Access Compliance Report

Public Rights-of-Way

(Curb Ramps)

Intersection ID: 13488	Main Street: E_BLAND_ST	Cross Street: S_COLLEGE_ST	Location: E
ADA ID: 033E475A9AE5	Ramp Type: Perp	Initial Pass/Fail: Fail	Overall Compliance: No
Severity Score: 33.75			
Codes/Mitigation Info/Possible Solution		Field Measurements/Component Compliance

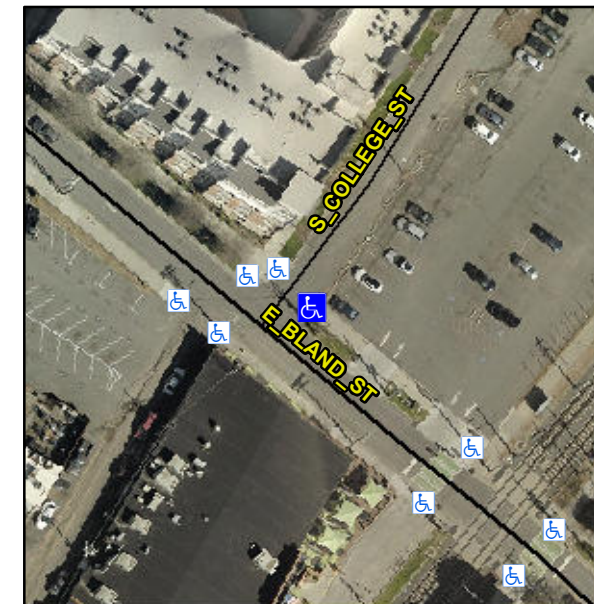
R304.5.1, R304.5.3

Compliance	Description	Data	Compliance	Description	Data
N/A	Ramp Length (in)	56.0	Yes	Ramp Slope (%)	6.9
No	Ramp Width (in)	47.0	No	Ramp XSlope (%)	8.2
N/A	Flare Type LT	N/A	N/A	Flare Type RT	N/A
N/A	Flare Slope LT (%)	N/A	N/A	Flare Slope RT (%)	N/A
N/A	Flare Traversable LT?	N/A	N/A	Flare Traversable RT?	N/A
N/A	Landing Length (in)	N/A	N/A	DWS Provided?	N/A
N/A	Landing Width (in)	N/A	N/A	DWS Contrast?	N/A
N/A	Landing Slope (%)	N/A	N/A	DWS Length (in)	N/A
N/A	Landing X Slope (%)	N/A	N/A	DWS Full Width?	N/A
N/A	Landing Curb? (Y/N)	N/A	N/A	DWS Offset (in)	N/A
N/A	Shared Landing?	N/A			
N/A	Gutter Ponding?	N/A	N/A	Gutter Slope (%)	N/A
N/A	Gutter Lip Ht (in)	N/A	N/A	Gutter X Slope (%)	N/A
N/A	Painted X Walk1?	No	N/A	Painted X Walk2?	N/A
	X Walk 1 Direction	To NW		X Walk 2 Direction	N/A
N/A	X Walk 1 Width (in)	N/A	N/A	X Walk 2 Width (in)	N/A
	X Walk 1 Slope (%)	4.0		X Walk 2 Slope (%)	N/A
	X Walk 1 X Slope (%)	9.6		X Walk 2 X Slope (%)	N/A

Remove & Replace Entire Ramp.
